Site Plan Review Committee (SPRC)

Americana Hotel

(SPLN22-00004)

New Site Plan, Rezoning, Minor Site Plan Amendment

Preliminary Staff Issues

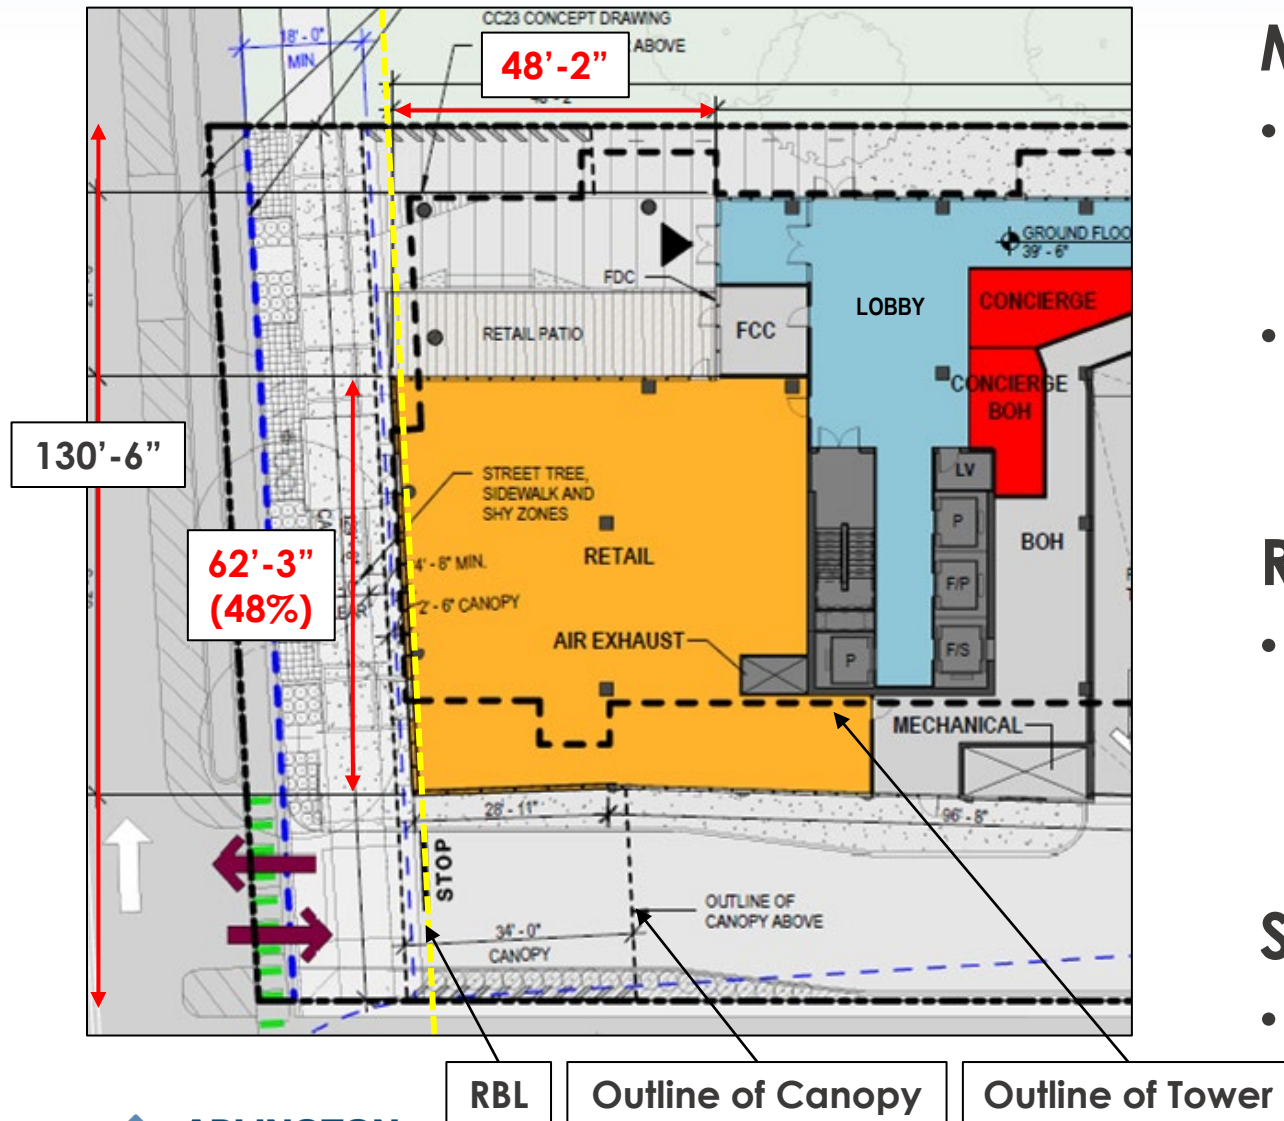
Minimum Frontage Requirements

- All podiums should engage the RBL within 0-2 ft for a minimum of 80% of the street frontage
- No portion of the podium façade should be located greater than 10 ft from the RBL

Required Building Frontage

- Every building should have at least 1 podium frontage on an RBL for a minimum of 65 ft along the RBL

Setback Profiles

- Multiple or single setback approach
